## TECHNICAL BULLETIN

**505-20-23**

**MODEL AFFECTED:** 505

**SUBJECT:** GARMIN G1000H SOFTWARE 006-B2472-02,  
INTRODUCTION OF.

Figure 1 - ECU Fail Wiring Diagram

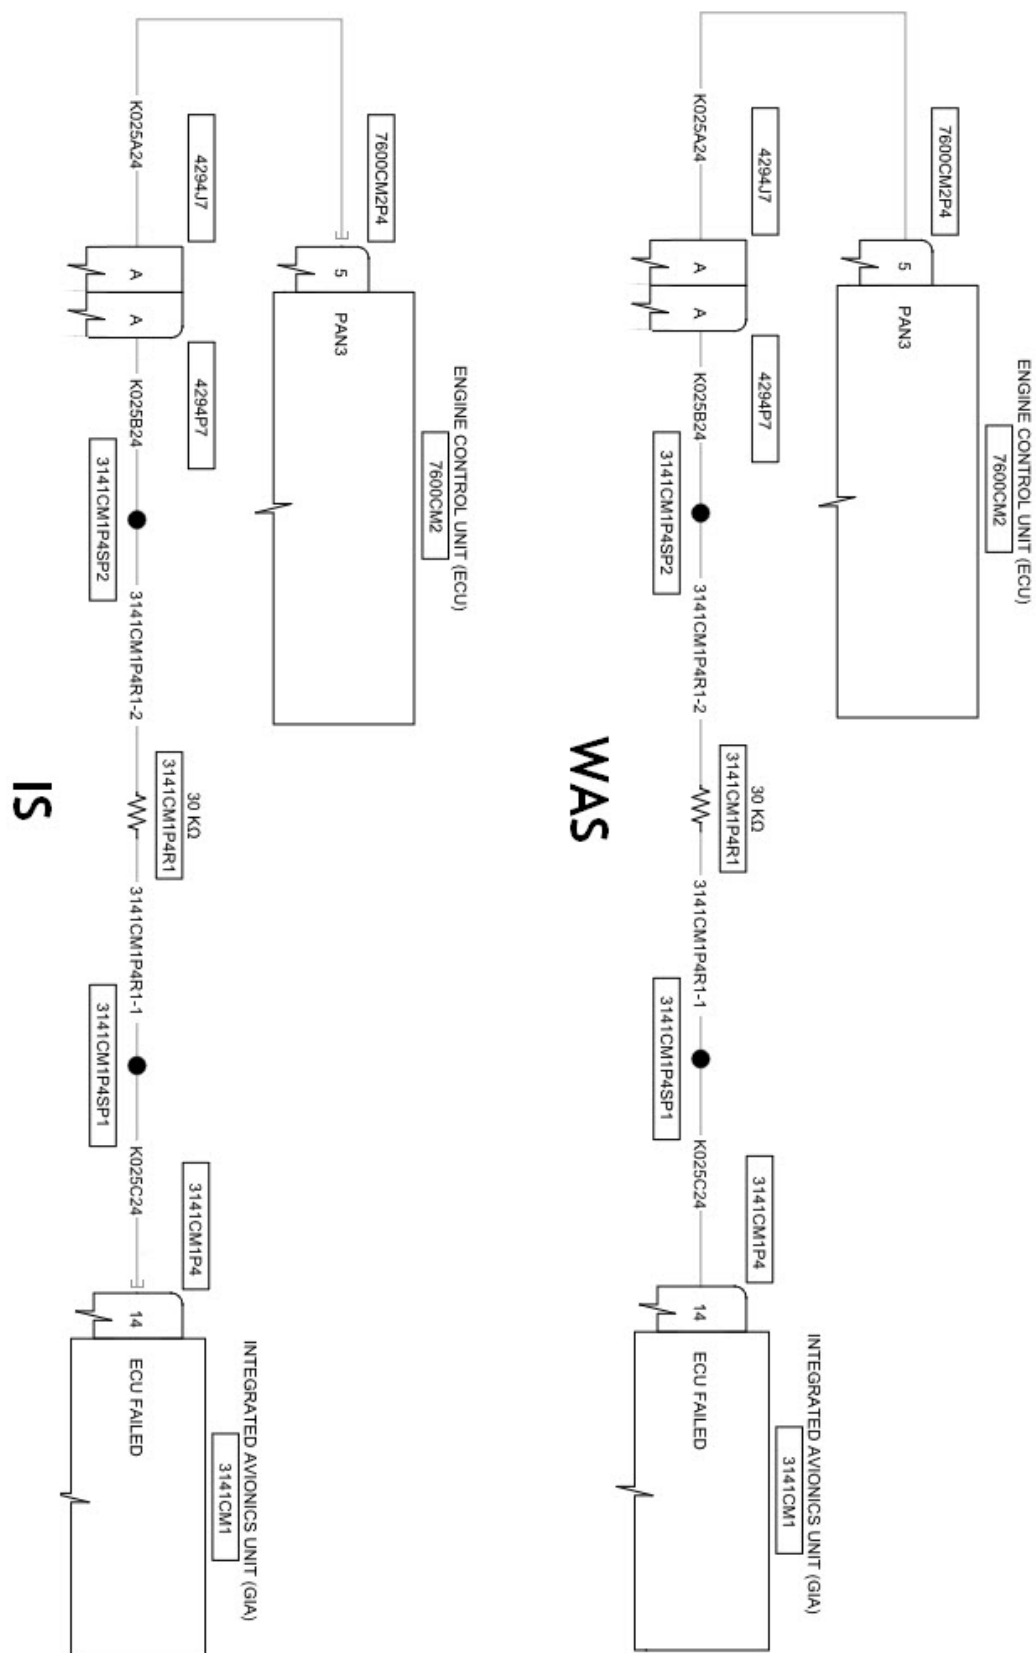
4. Perform specified wiring deletion as listed in Table 1 (Figure 1).
5. Re-Identify harness identification near 7600CM2P4 by adding the suffix letters “FM” to it (Field Modified).
6. Re-Identify harness identification near 3141CM1P4 by adding the suffix letters “FM” to it (Field Modified).
7. Inspect and close affected accessed zones ([DMC-505-A-05-40-00-00A-028A-A](#)).
  - a. Zone 192 – Right aft fuselage.
  - b. Zone 433 – Lower main rotor drive compartment.
8. Make an entry in the helicopter logbook and historical service records indicating compliance with **PART I** of this Technical Bulletin.

**Table 1 – Wiring Modification Instruction Table**

| Action | Wire #  | Connector (pin location) | Extraction Tool | Notes |
|--------|---------|--------------------------|-----------------|-------|
| Delete | K025A24 | 7600CM2P4 (5) (ECU)      | M81969/14-01    | 1     |
| Delete | K025C24 | 3141CM1P4 (14) (GIA)     | M81969/14-01    | 1     |

**NOTE 1:** Cap and stow wires at connector's end. Refer to Figure 2 or BHT-ELEC-SPM for additional information on connector termination.
